SPECIFICATION OF THE *BLUETOOTH* SYSTEM

Bluetooth Core Specification Addendum 3 rev. 2

Adoption Date: 24 July 2012

**Bluetooth®
Addendum 3**

Figure 10.2: Flow chart for a client issuing a service request

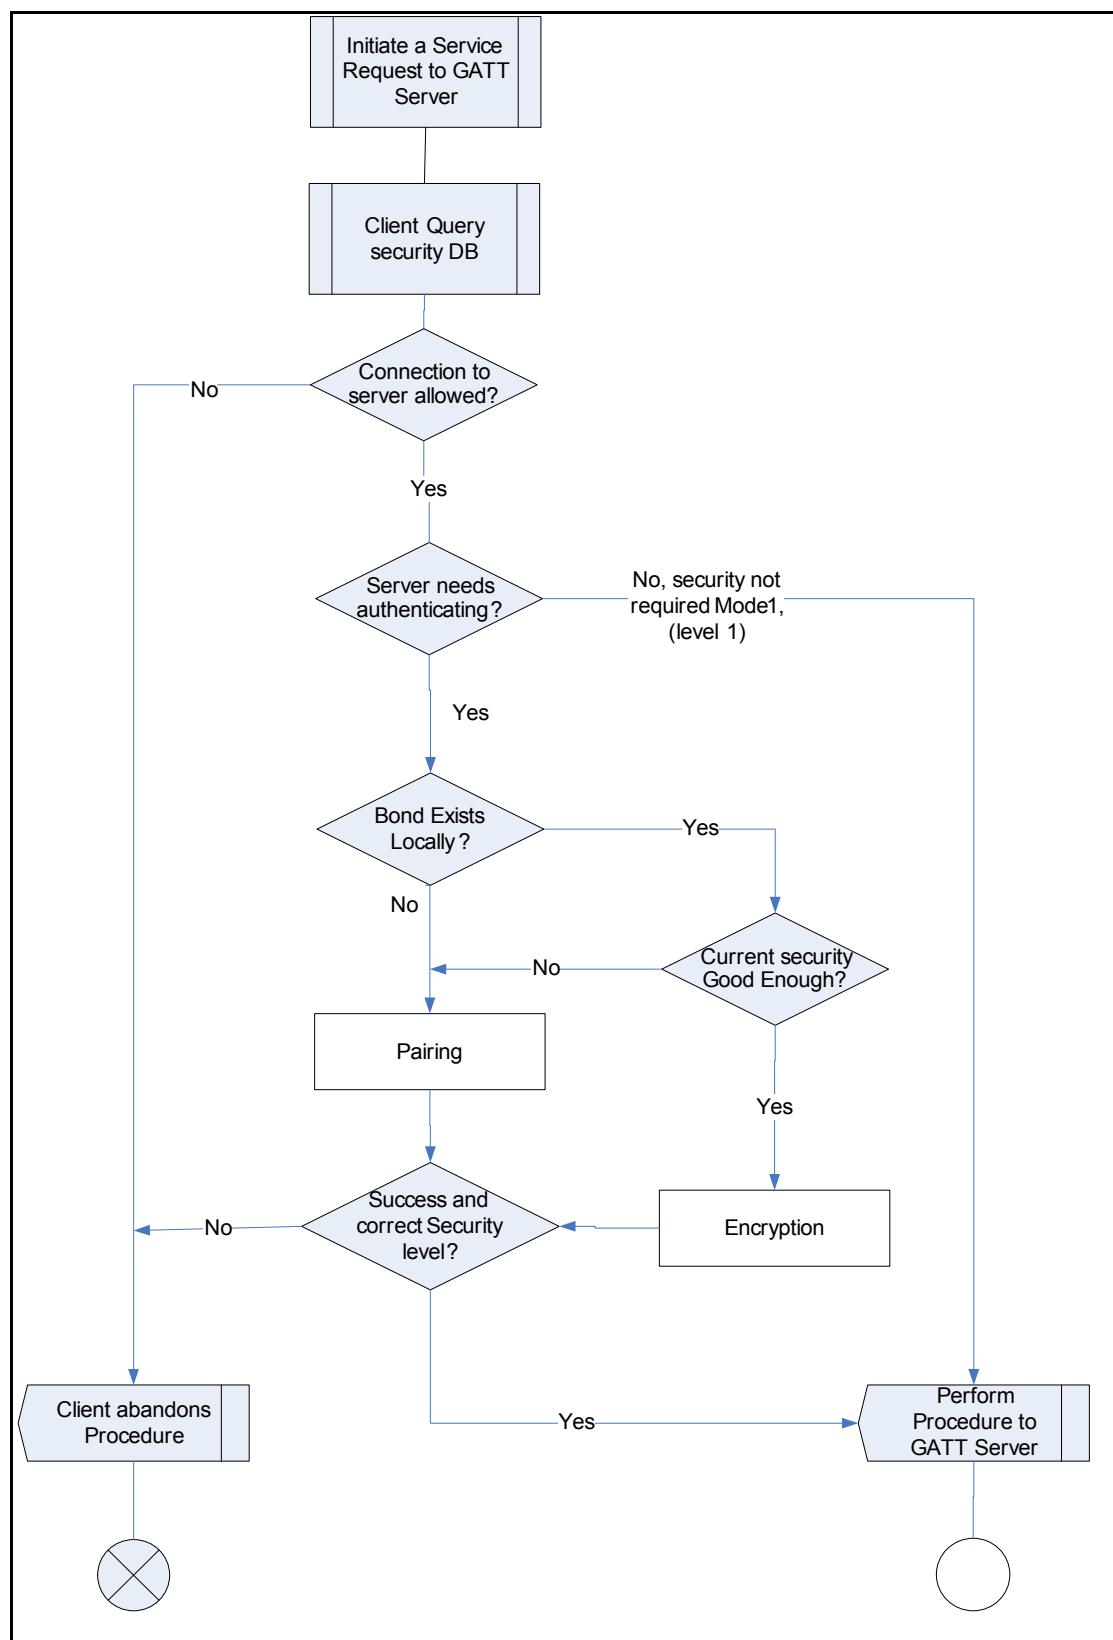
[Add new section 10.3.1.1]

2.2.9 Erratum 4208 - Figure 9.4 flow chart is a copy paste mistake except for the first rectangular box that says

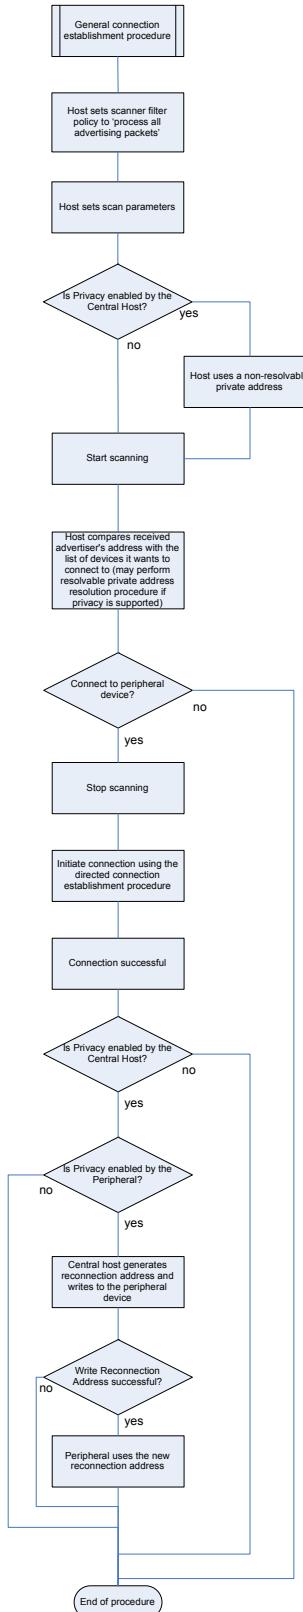
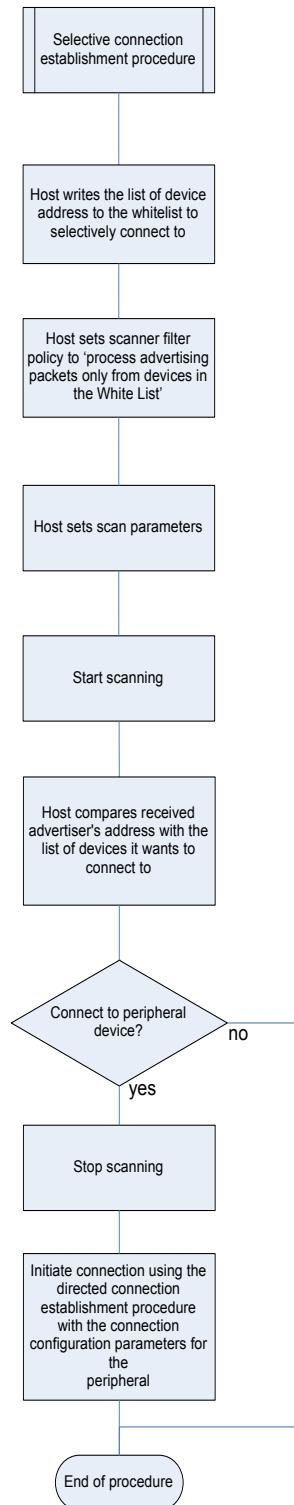
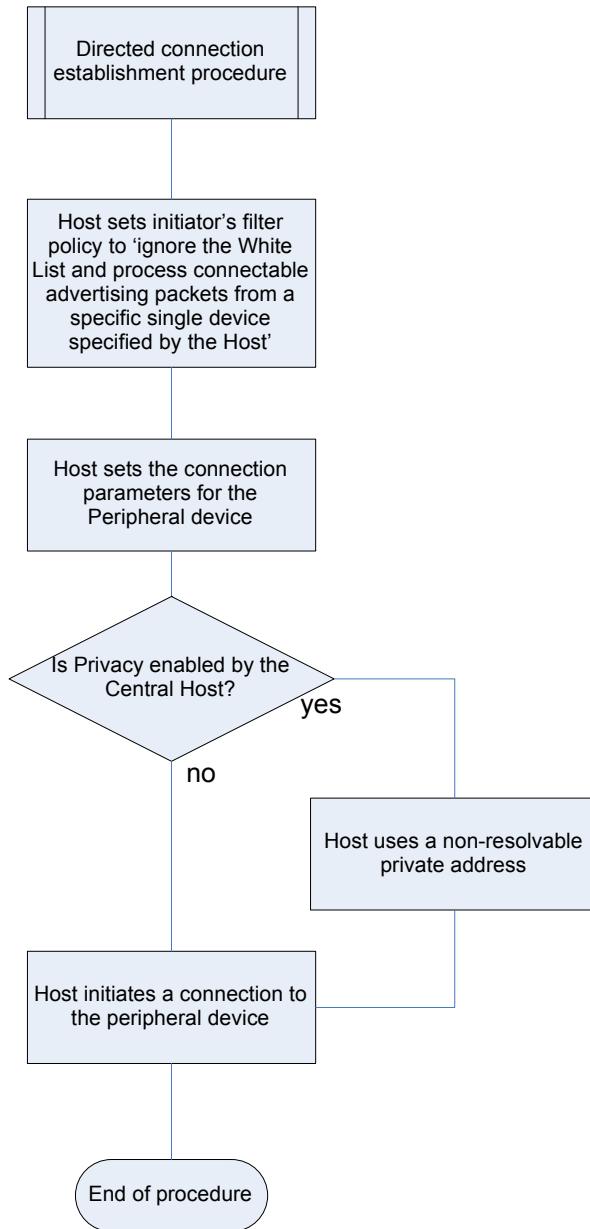
Section: 9.3.4.2 Conditions, Figure 9.4, page 350

[Replace Figure 9.4 with the following figure]

Section: 9.3.5.2 Conditions, Figure 9.5, page 353**[Replace Figure 9.5 with the following figure]**

Section: 9.3.6.2 Conditions, Figure 9.6, page 355

[Replace Figure 9.6 with the following figure]

Figure 5.12: Slave rejects pairing because of key size

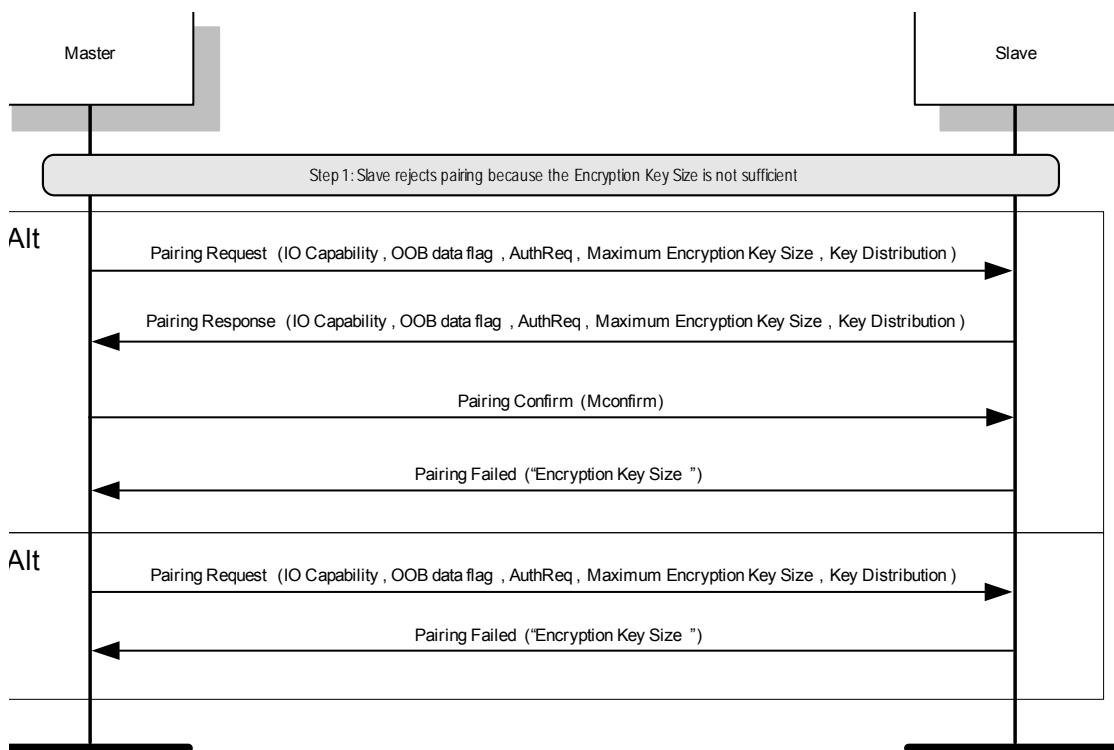
2.5.9 Erratum 4163 - Figure 5.12 issue

Section: 5.3.5.3 Slave Rejects Pairing Because of Key Size, page 650

[Replace figure 5.12 with]

Figure 4.5: Connectable undirected advertising event during which a CONNECT_REQ PDU is received

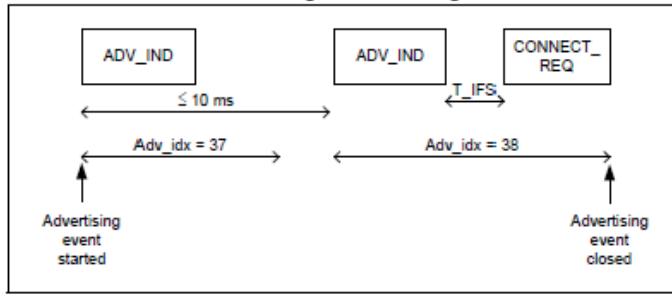
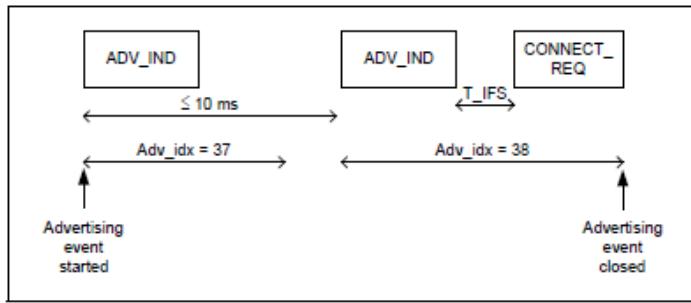
Section: 4.4.2.3 Connectable Undirected Event Type, figure 4.5, page 61

[Original caption]

[Move the caption to below figure 4.5]
